HISTORIC AND DESIGN REVIEW COMMISSION

October 19, 2022

HDRC CASE NO: 2022-503
ADDRESS: 302 RIDDLE ST
LEGAL DESCRIPTION: NCB 728 BLK 10 LOT 1
ZONING: RM-4, H
CITY COUNCIL DIST.: 1
DISTRICT: Lavaca Historic District
APPLICANT: Luis Ocura/CoSA (Public Works)
OWNER: Luis Ocura/CoSA (Public Works)
TYPE OF WORK: Sidewalk and ADA ramps installation
APPLICATION RECEIVED: September 21, 2022
60-DAY REVIEW: Not applicable due to City Council Emergency Orders
CASE MANAGER: Claudia Espinosa
REQUEST:

The applicant is requesting a Certificate of Appropriateness for approval for a sidewalk project on the southeast side of Riddle St accompanied by ADA ramps on the intersections of Devine and Sadie.

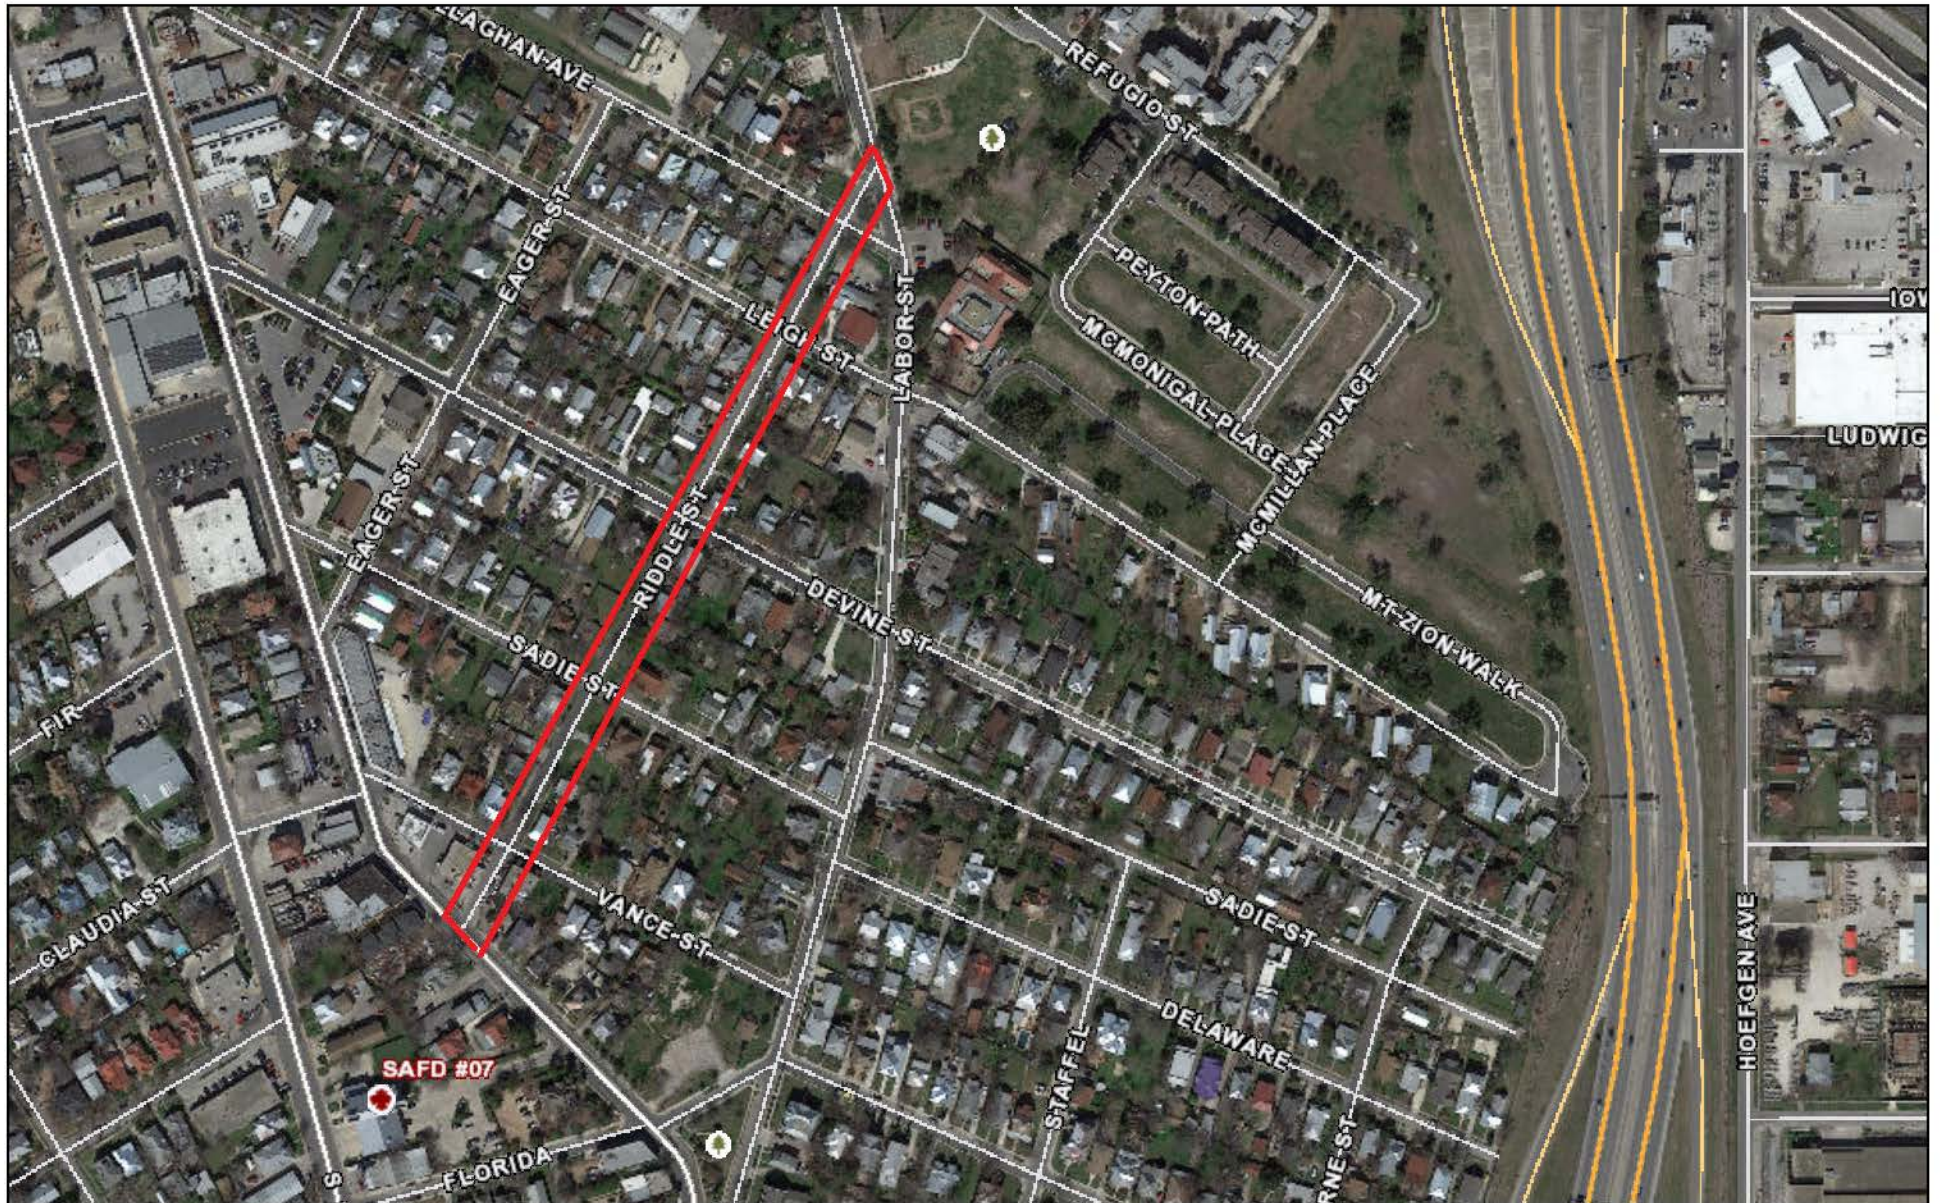
- a. **SIDEWALK INSTALLATION** – The applicant has proposed to install sidewalks along the southeast side of Riddle Street between Callaghan and Sadie with ADA ramps on Devine and Sadie. The applicant has provided sidewalk dimensions from the existing curbing at this time. The Guideline 5.A.iii for Site Elements states that the installation of new sidewalks should follow the historic alignment, configuration, and width of sidewalks and walkways. Additionally, the Guidelines note that the historic width or alignment of sidewalks should only be altered where

absolutely necessary to accommodate the preservation of a significant tree. Additionally, Guideline 5.C.i for Site Elements states that historic curbing should be retained wherever possible. Historic curbing in San Antonio is typically constructed of concrete with a curved or angular profile. Staff finds the proposed scope of work to be appropriate.

- b. **DRIVEWAY APPROACH INSTALLATION** – The applicant has proposed to install a driveway approach along the project area. The Historic Design Guidelines for Site Elements state that the width and configuration of original curb cuts should be maintained when replacing historic driveways. The introduction of new curb cuts were not historically found should be avoided. New driveway approaches installed where a historic ribbon driveway exists should tie into the existing ribbon driveway and not feature full-width penetration; the historic ribbon configuration must be maintained. Any new driveway approaches installed should not exceed 10 feet in width, approaches requested for additional width require additional review. Staff finds that any modifications to existing driveway approach widths or material will require additional review.

- c. **ADA RAMP INSTALLATION** – The applicant has proposed to install ADA ramps at the corners of Devine and Riddle Street, and Sadie and Riddle St. Guideline 8.C.iii for Site Elements states that new ADA curb cuts on historic sidewalks should be installed to be consistent with the existing sidewalk color and texture while minimizing damage to the historic sidewalk.

Staff recommends approval as submitted based on finding a. Any tree removal must be correlated with the city arborist.
